3.0 General Amendments

Proposed Design Changes - North elevation

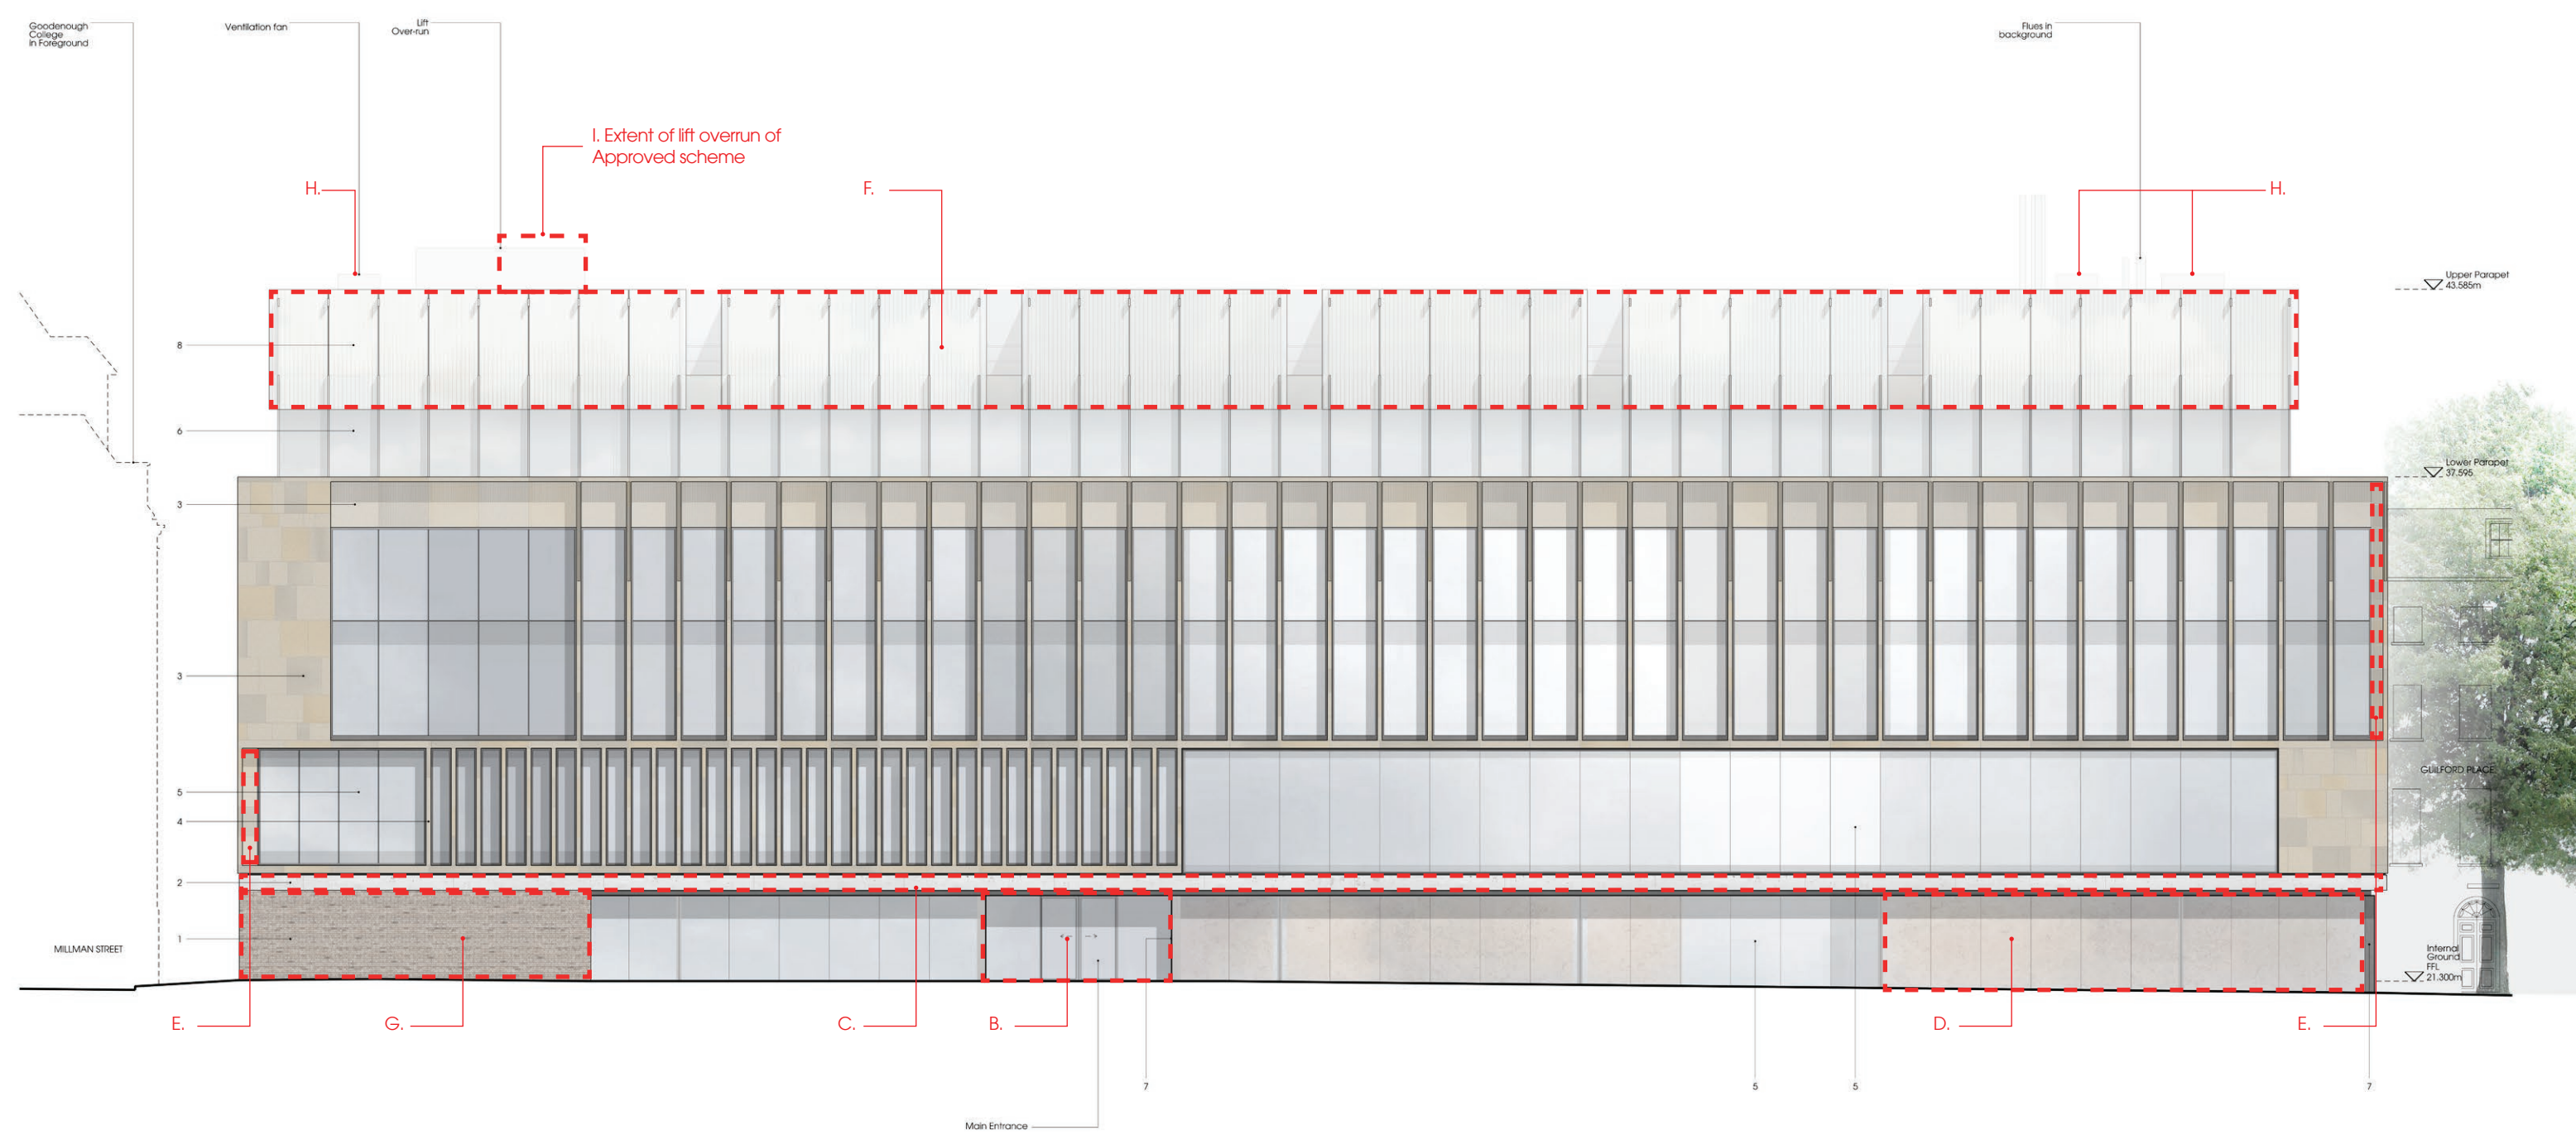
- B. Main entrance : 1 set of double sliding doors instead of 2
- C. GRC in lieu of precast cladding to first floor fascia
- D. Internal brick wall within the ground floor laboratory space replaced by an alternative lining (finish and material under review)
- E. Technical development of terracotta cladding to NE and NW corners.
- F. GMP glazing details
- G. Stretcher bond in lieu of English bond brickwork on ground floor
- H. Ventilation fans added on roof level
- I. Lift overrun dimensions changed
